**HIGHLANDS COUNTY
BOARD OF COUNTY COMMISSIONERS
(HCBCC)
PURCHASING DIVISION**

BID NO. ITB 19-005 ADDENDUM No. 3

Project: 19-005 Sebring Parkway Phase IIA Project No. 17062- #429841-1-54-01,
Sebring Parkway Phase IIB Project No. 17063- #433553-1-54-01, and
the City of Sebring Utility Modifications

SEBRING PARKWAY - PHASE II
 SEBRING PARKWAY
 PLAN AND PROFILE
 STA 470+00 TO STA 483+00

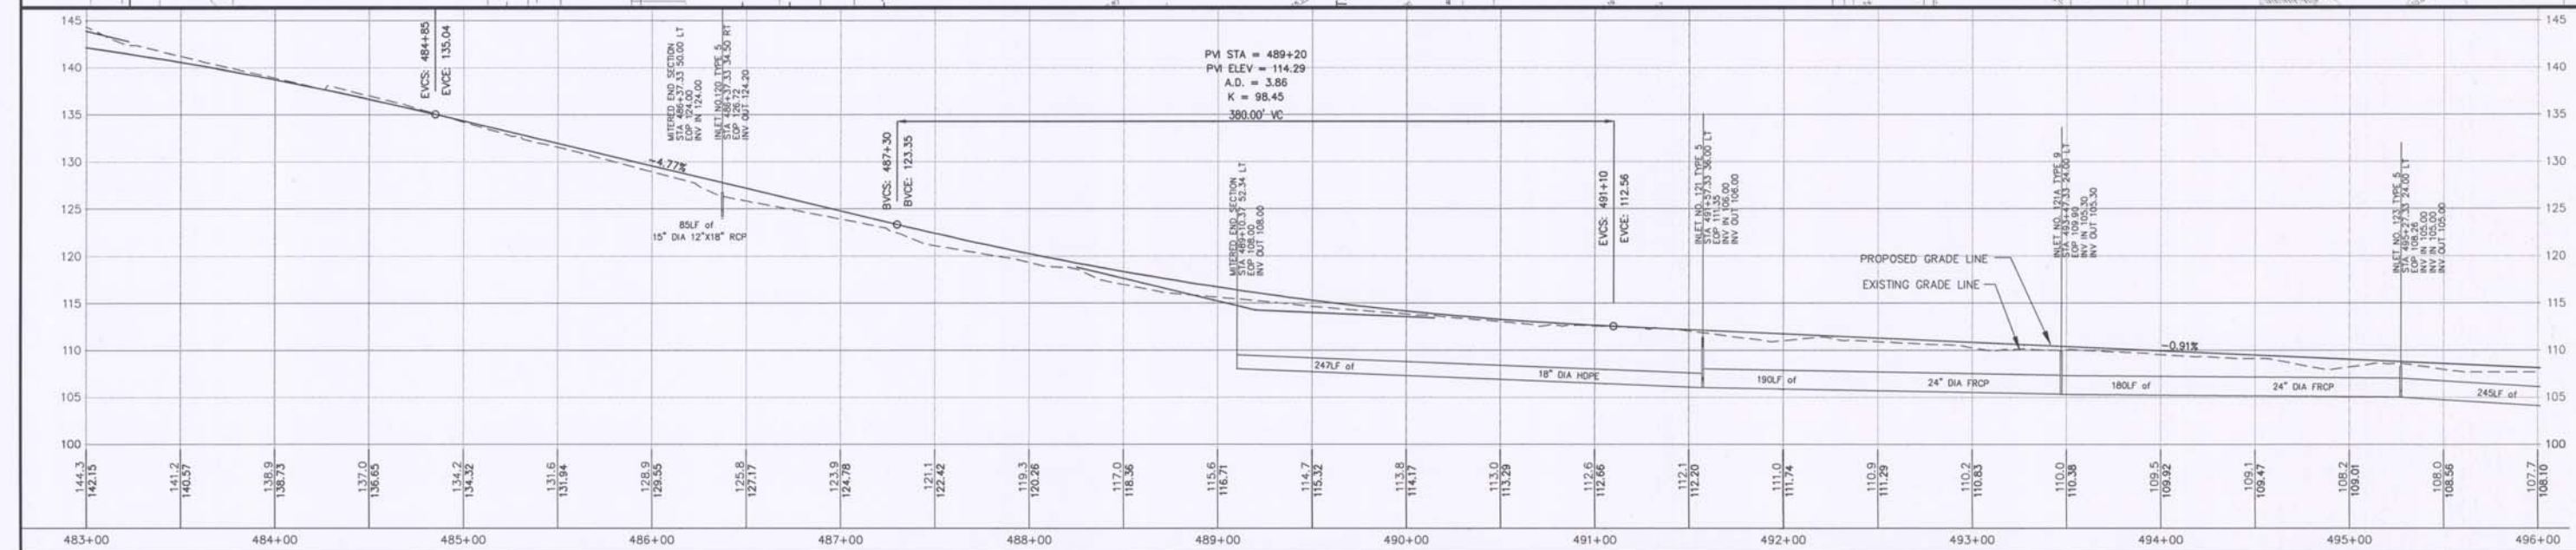
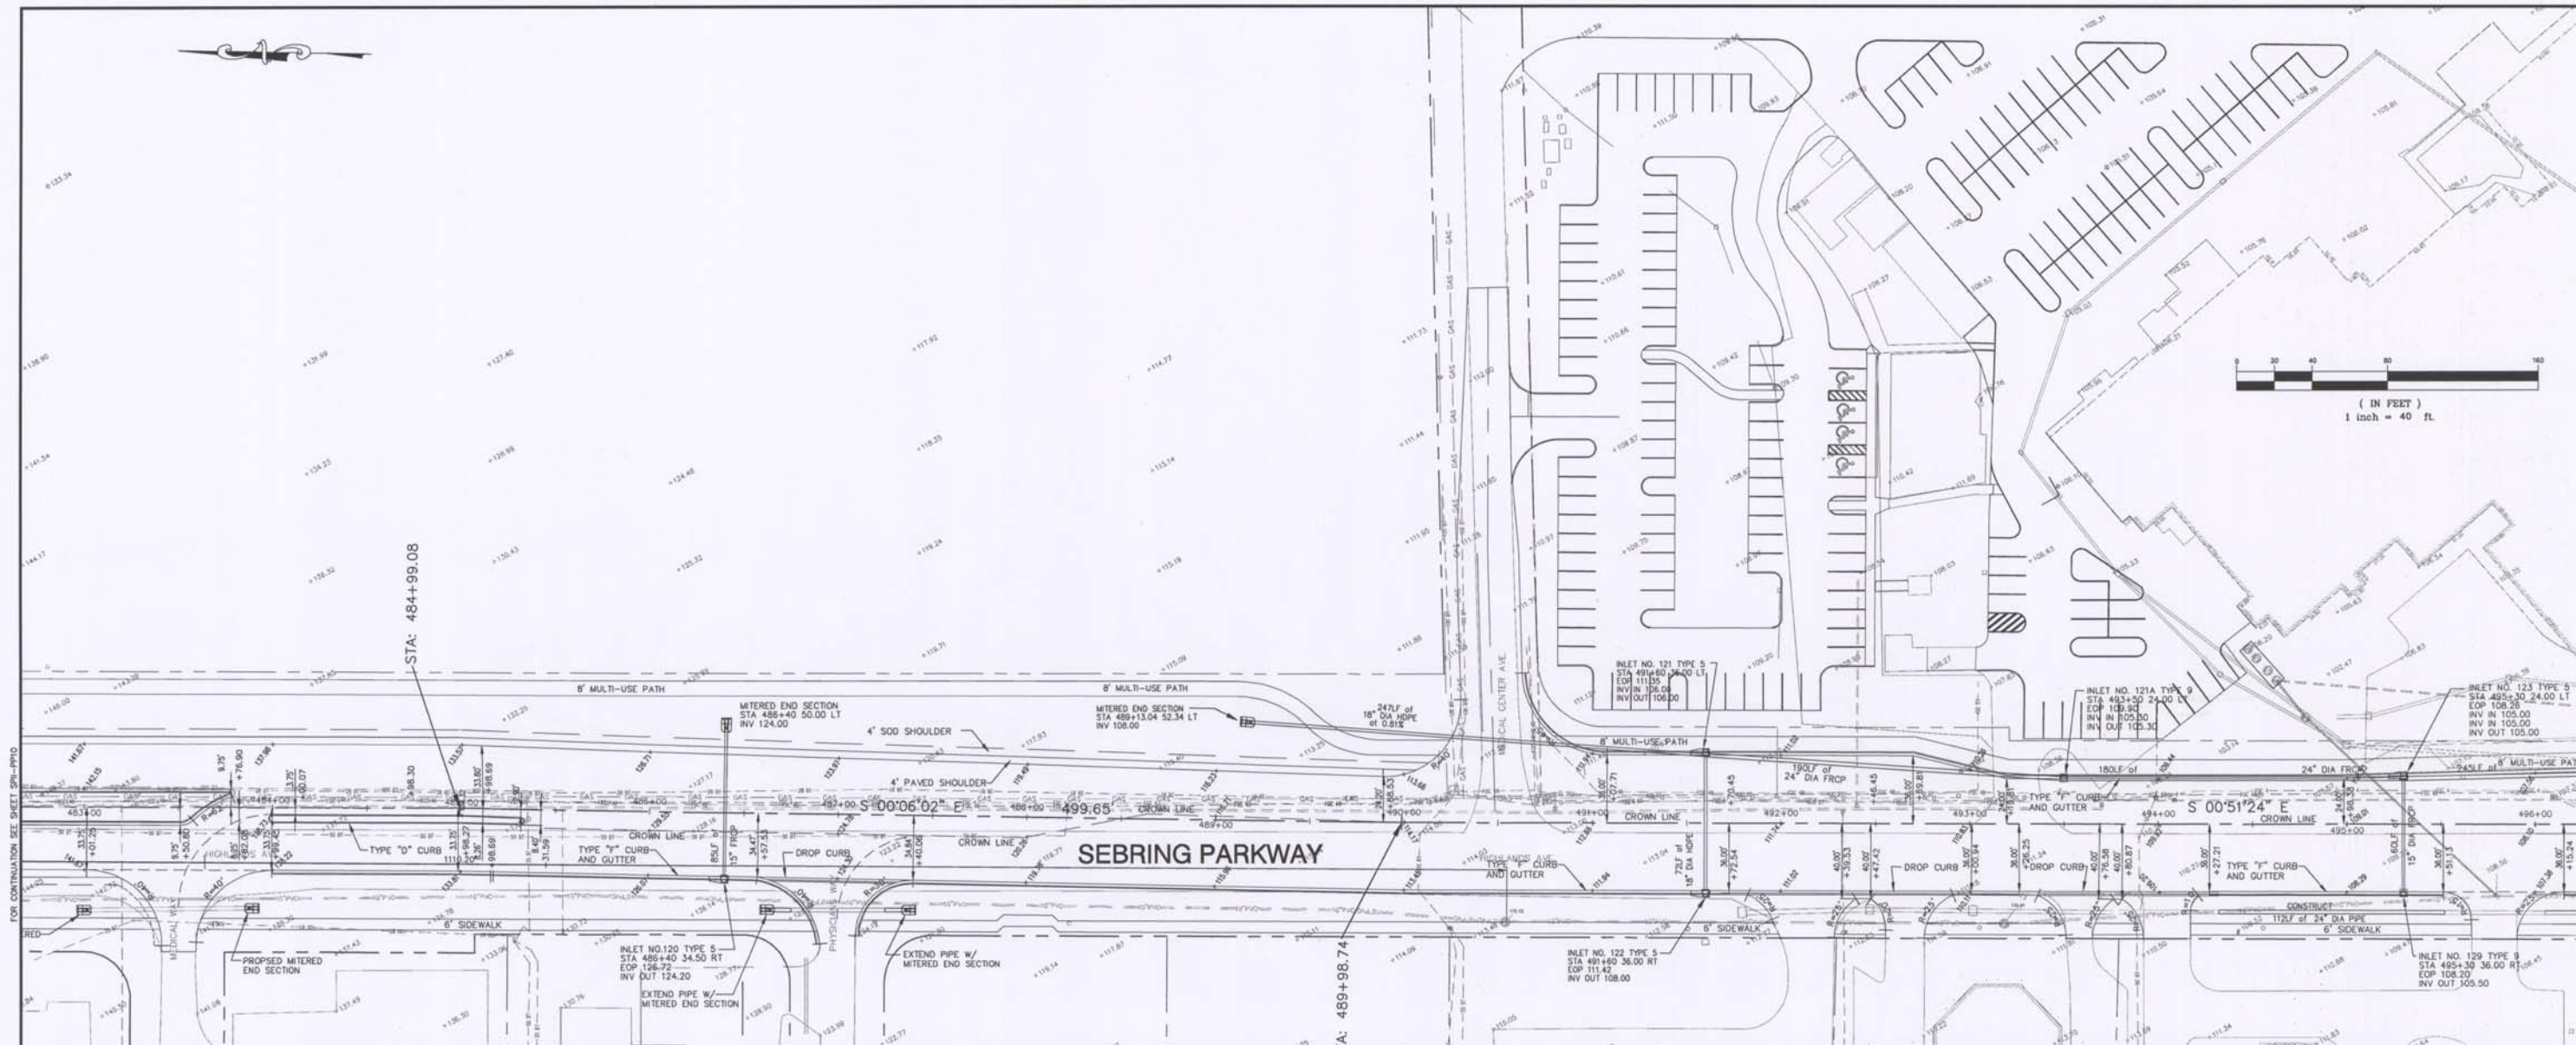
All proposed 6" water line beginning at Station $\pm 468+22$ to Station $\pm 476+30$ will be upsized to 8". All fittings, valves, connections, casings, etc.... will be upsized accordingly.
